**JOINT REGIONAL PLANNING PANEL
(Sydney East Region)**

JRPP No	2016SYE040
DA Number	16/18
Local Government Area	City of Botany Bay
Proposed Development	Joint Regional Planning Panel and Stage 2 Integrated Development Application for the construction of a mixed use development incorporating 487 apartments and a childcare centre within a building consisting of a 5 storey podium including 847 car spaces sleeved with apartments and 2 x 16 storey and 2 x 20 storey towers above.
Street Address	130-150 Bunnerong Road, Pagewood NSW 2035
Applicant	Karimbla Constructions Services (NSW) Pty Ltd
No. of Submissions	Three (3) submissions
Regional Development Criteria	Development with a CIV of \$116,742,078
List of All Relevant s79C(1)(a) Matters	• Environmental Planning & Assessment Act 1979, Part 4 – Development Assessment & Schedule 4A – Development for which regional panels may be authorised to exercise consent authority functions of councils • Environmental Planning & Assessment Regulation 2000, Part 6 – Procedures relating to Development Applications • State Environmental Planning Policy (Infrastructure) 2007 • State Environmental Planning Policy No. 55 – Contaminated Land • State Environm

Figure 24. Building Separation Plan Stage 1 consent DA-14/96

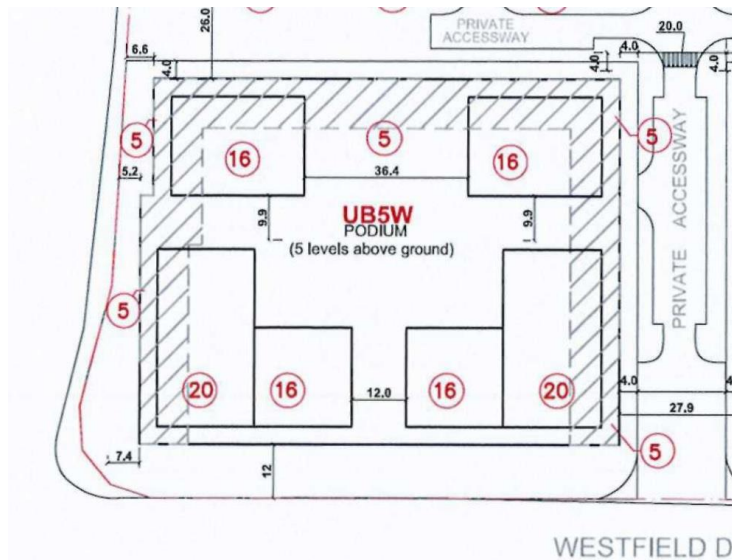
The 'building separation plan' shows 12 metre separations between the northern and southern towers and between the two southern towers which is the separation that has been provided. This plan does not indicate that these facades would have habitable openings. In such a case where there is no habitable openings (ie. non-habitable) then the 12 metre separations would be compliant with the ADG. However, it is clear from the 'indicative apartment layout plan' that habitable openings including a single aspect apartment were anticipated to the southern facades of the northern towers. Also, the plans indicate red dotted lines to the opposing northern facades of the southern towers and between the opposing facades of the two southern towers. These red dotted lines are annotated to be 'non-habitable openings or blank facades, or appropriate treatment for habitable openings (ie. highlight windows, louvers, screens, opaque glazing)'. Accordingly, habitable openings were also permitted to these opposing facades provided appropriate privacy treatments were included.

Figure 26. Privacy treatments and analysis to non-complaint separations

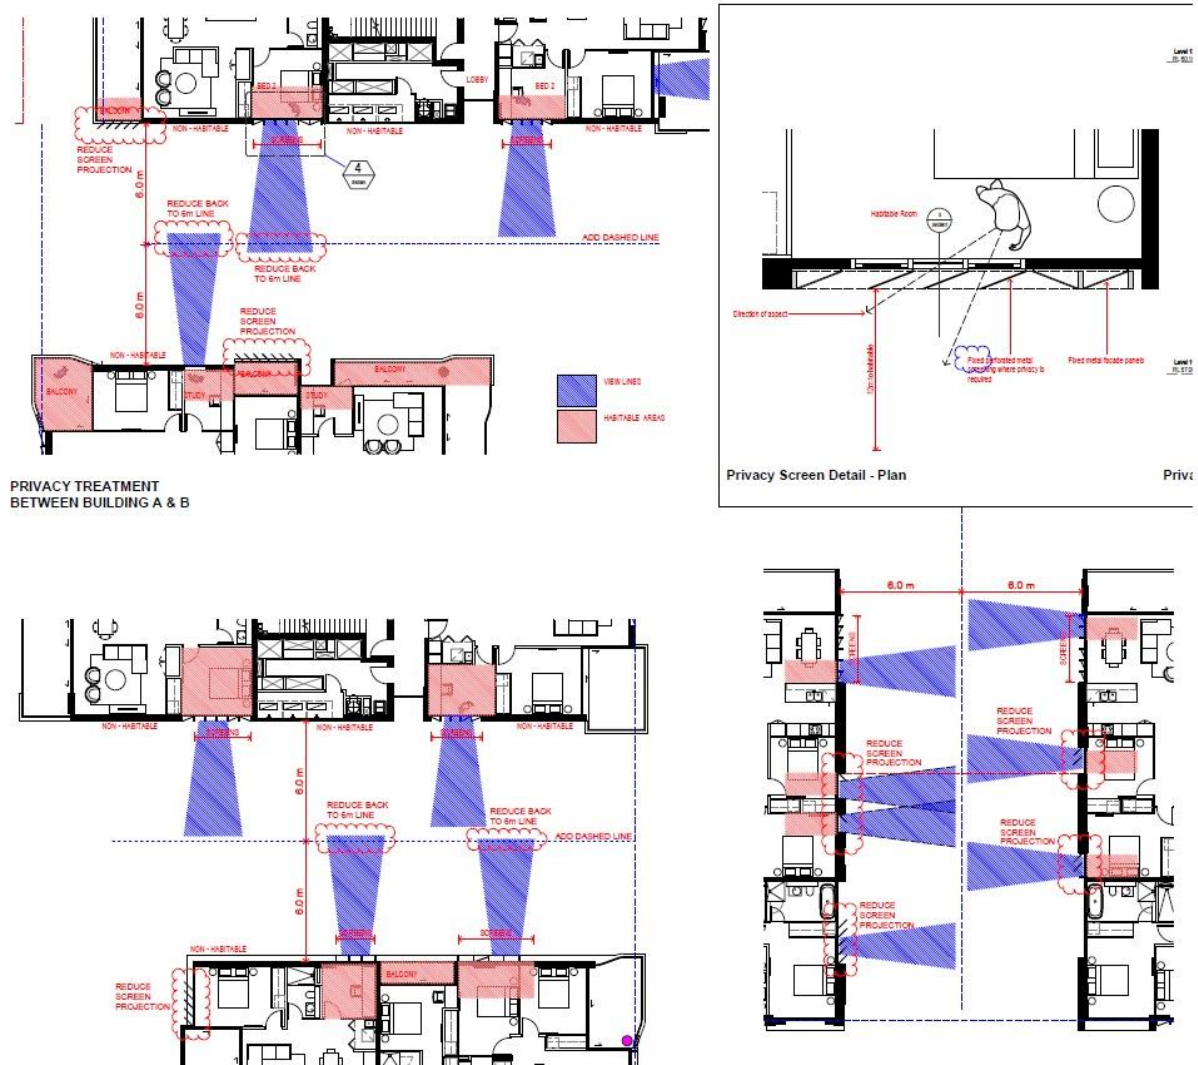
The plans as originally submitted did not include appropriate privacy treatments to these non-compliant facades. Council raised this concern with the applicant and amended plans were received providing additional privacy treatments. A privacy analysis was also provided as well as a design verification statement which confirms that the separation objectives have been achieved. As demonstrated in the submitted privacy analysis below, privacy has been provided through the use of fixed privacy

screens to windows and balconies which ensure that there are no sightlines between these habitable openings.

Given the above, Objective 3F-1 for the building separation controls is considered to have been achieved and as such the non-compliance is supported.

Figure 28. Tree Retention Plan – 30 trees to be retained are numbered in black.

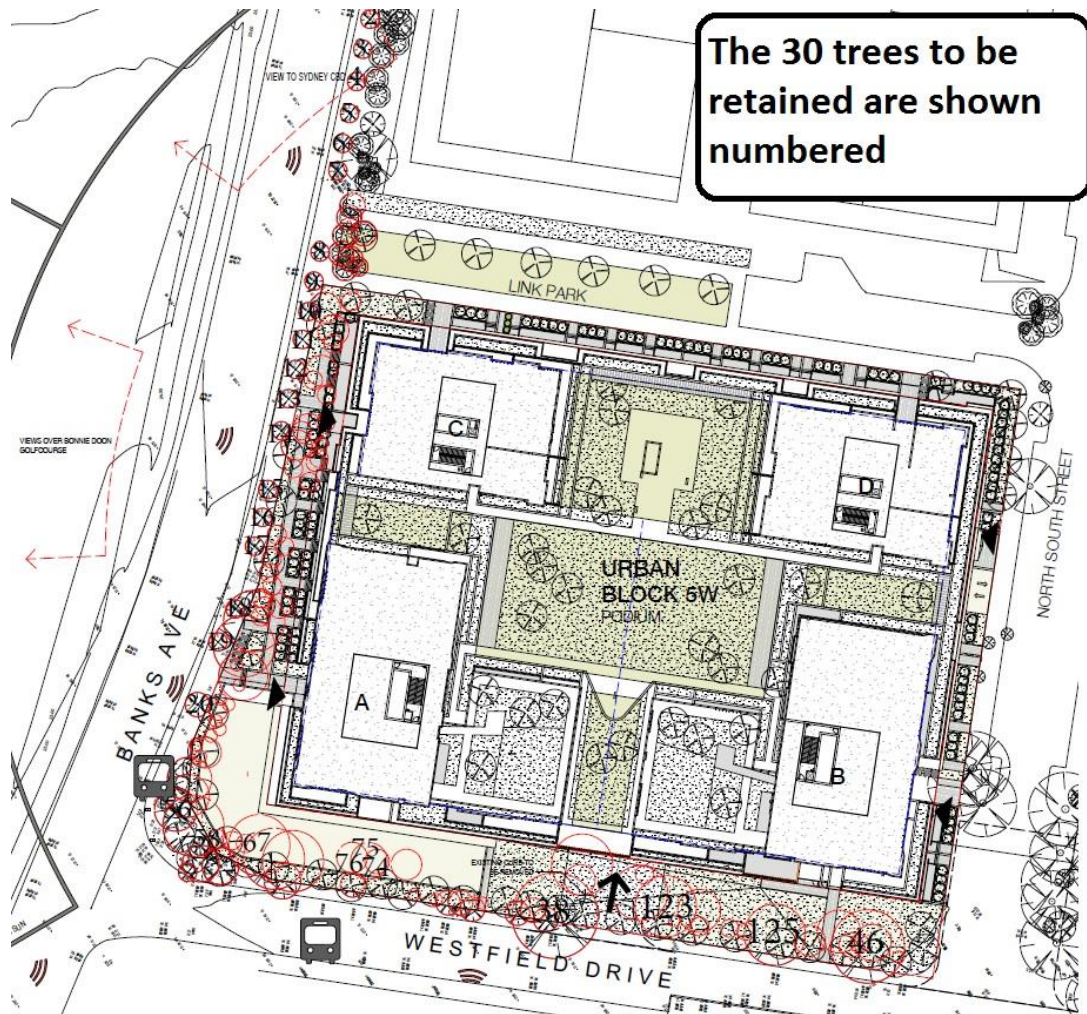
Within the Banks Avenue setback only the street trees are proposed to be retained. The remainder of the trees are to be removed either due to their proximity to the building or due to the proposed paving and landscaping areas. The proposal includes a pedestrian path internal to the site which runs parallel to the public footpath on Banks Avenue. This path is not considered to be necessary given that it contributes to the requirement to remove trees in this setback. Conditions have been included that

Within the setback to Westfield Drive, the majority of trees are proposed to be removed due to the proposed footpath within the site, the OSD tank, and proximity to the building. The proposed internal footpath is to run parallel to the existing public footpath within Westfield Drive. This path is not considered to be necessary given that it contributes to the requirement to remove trees in this setback. Furthermore, a large OSD tank is proposed in the setback adjacent to the building with trees to be removed on top of it with no replacement plantings. Conditions have been included requiring the deletion of the footpath and plantings to be provided on top of the OSD. Details are to be provided to and assessed by Council prior to any tree removal.

The Development Application was referred to Council's Landscape Architect who supports the proposed development subject to the above mentioned conditions.

Figure 32. Apartment type 2 Bed Type 4 includes a bedroom which is considered to have a saddleback design.

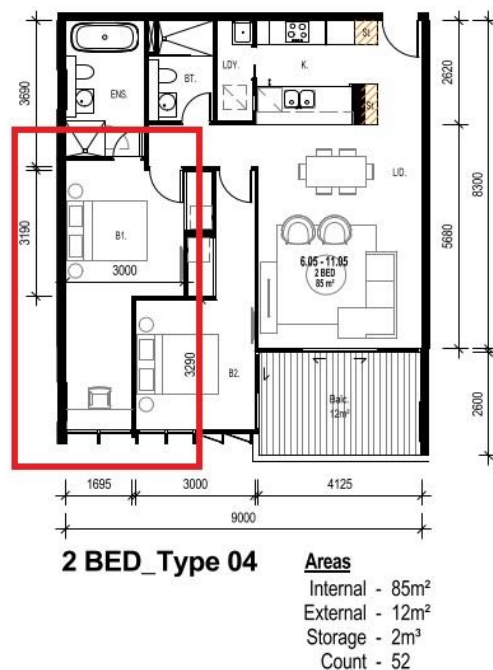
The intent of this control is to provide adequate amenity to bedrooms in terms of access to sunlight and natural ventilation. The saddle back design provided to this apartment type is considered to achieve this objective as the corridor is has a sufficient width at 1.7 metres and the length is not excessive at 3 metres. This creates a space with reasonable useability which is demonstrates as a study nook is provided at the end.

The issue has been raised with the applicant who has indicated that this design is not the preferred approach however is considered necessary given the Stage 1 consent conditions relating to minimum apartment size and the building envelopes which do not provide sufficient frontage lengths to avoid this situation. Alternative layouts have been explored but are not considered feasible as reducing the length of the saddle back would reduce the apartment to under the minimum unit size requirement of the Stage 1 consent.

It is considered that the one apartment type provided with a saddle back bedroom design is the result of the Stage 1 consent minimum apartment sizes and building envelopes. On balance, given the saddle back is only provided to one apartment type and the saddle back is not overly narrow or long, the non-compliance is considered acceptable.
